**Rezoning Transportation Analysis**  
**Petition Number: Insert Zoning Petition #2021-161**  
*General Location Identifier: 22902119*

Revision Log:	Date	Description
	08-20-2021	First Review (WB)
	09-17-2021	Second Review (WB)
	10-18-2021	Second Review (WB)
	11-22-2021	Fourth Review (AO)

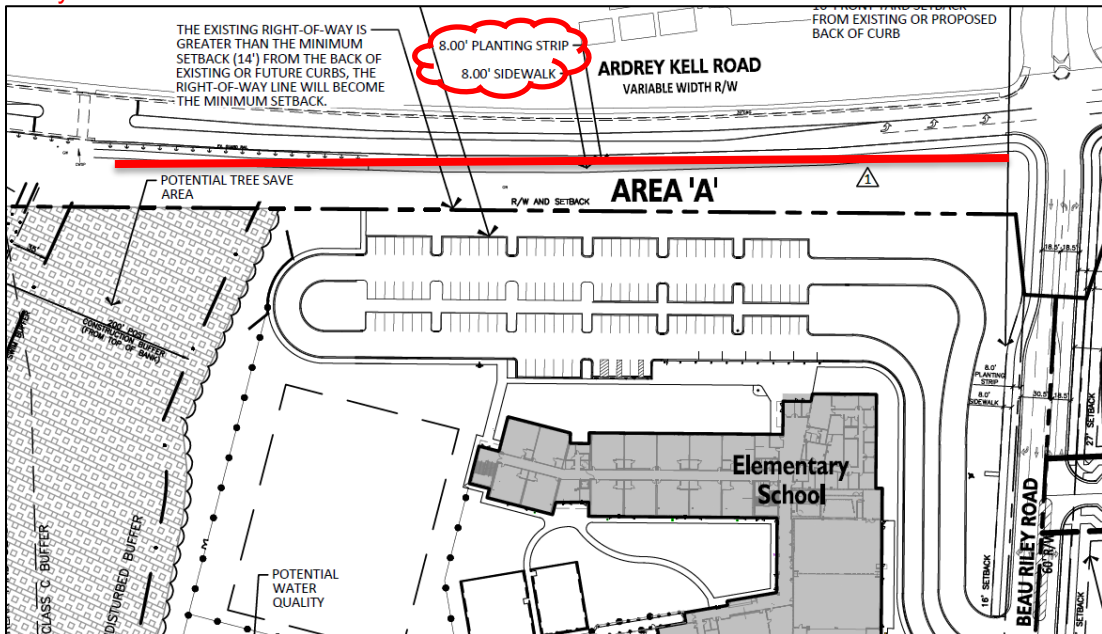
- a. ~~Ardrey Kell Road: The existing curb and gutter is in its future location. No curb relocation required.~~
- b. ~~Beau Riley Road: The existing curb and gutter is in its future location. No curb relocation required.~~

~~Label and dimension the curb and gutter from the centerline for each road on the site plan.~~
